**AN ANALYSIS OF THE DESIGN AND PERFORMANCE OF
THE CLAY CAP USED TO CONTROL GROUNDWATER
RECHARGE INTO THE FRACTURED BEDROCK BENEATH
THE FORMER SODIUM BURN PIT (FSDF) AT THE FORMER
BOEING-ROCKETDYNE SANTA SUSANA FIELD
LABORATORY**

William C. Bianchi, Ph.D.

October 5, 2006

Disclaimer: This study was prepared for the Santa Susana Field Laboratory Advisory Panel, a project of the Tides Center. The work of the Panel was conducted under a contract with the California Environmental Protection Agency pursuant to funds provided by the California Legislature. The statements and conclusions in this report are those of the contractor and not necessarily those of the California Environmental Protection Agency. The mention of commercial products, their source, or their use in connection with material reported herein is not to be construed as actual or implied endorsement of such products.

Hydraulic Conductivity In Different Units As Related to Particle Size Definitions

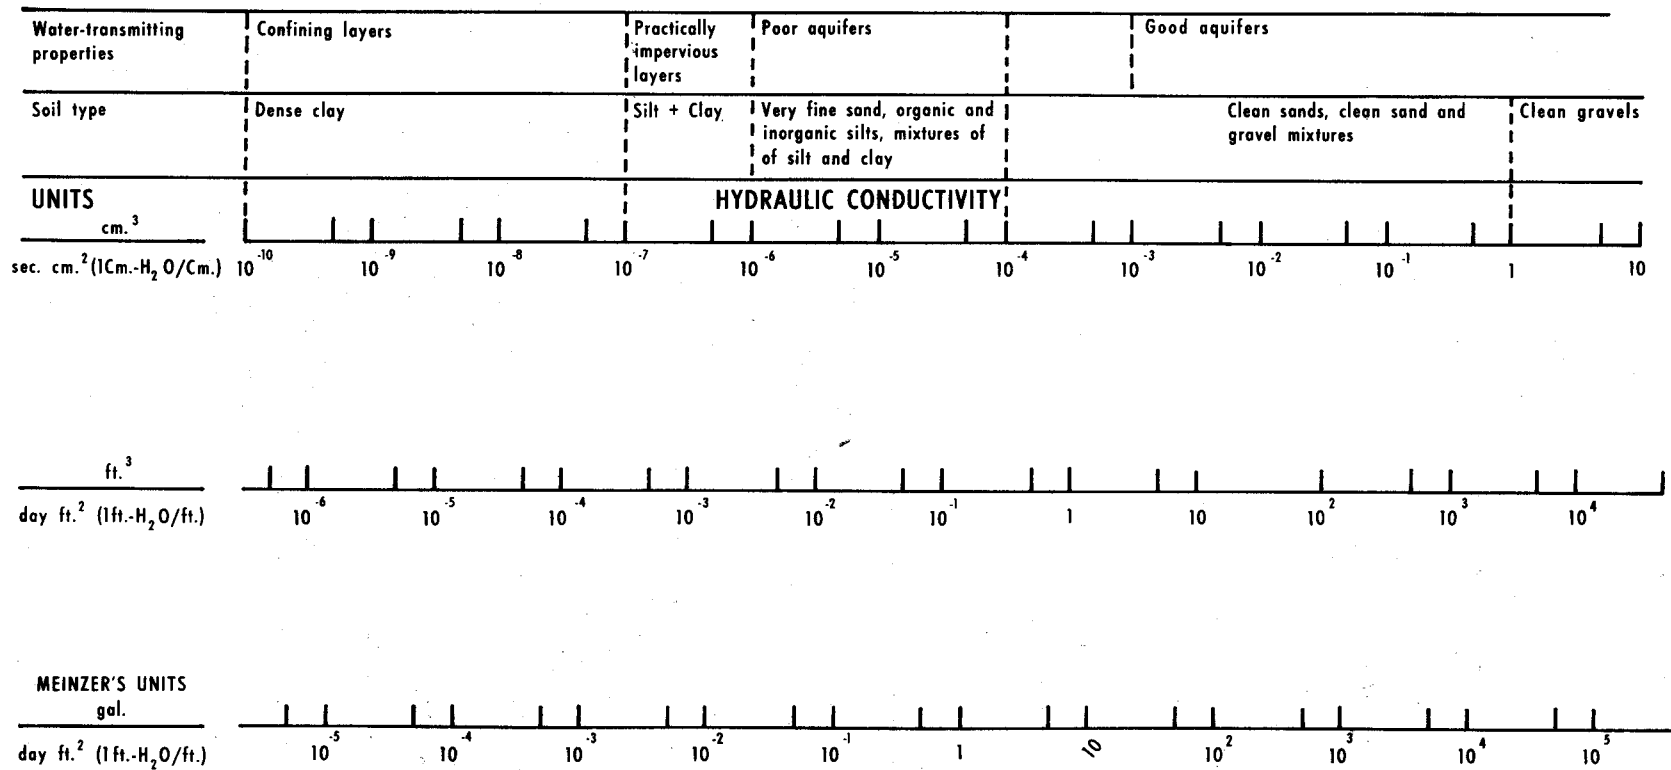
The proposed physical solution now in place designed to isolate the pollutant materials in the bedrock consists of placement of what is defined as a “clay cap”, a soil backfill put in place after the original soil and the pollutants it contained were removed down to the bedrock basement of the pit area (Interim Measure Work plan, July 9, 1999). The thickness of this cap is at least 1 foot and no greater than 12 feet. This backfill was excavated from a barrow pit area on the facility. The laboratory soil particle size analysis (see Infiltration Monitoring Work plan, Former Sodium Disposal Facility, IT Corp. April 14, 2000, appendix A and A1) puts this fill material in the silty clay to silty clay loam soil class according to textural standards (USDA Soil Survey Manual #18). The field water transmission performance of these textural classes as viewed by geohydrologists is shown in Figure 1. As seen here this textural range places the water

transmitting properties in the class of a poor aquifer, not in the impervious range. Again, this cap was meant to prevent future percolation of rainfall into the crack matrix of the bedrock and thus eliminate further downward mobilization of pollutants.
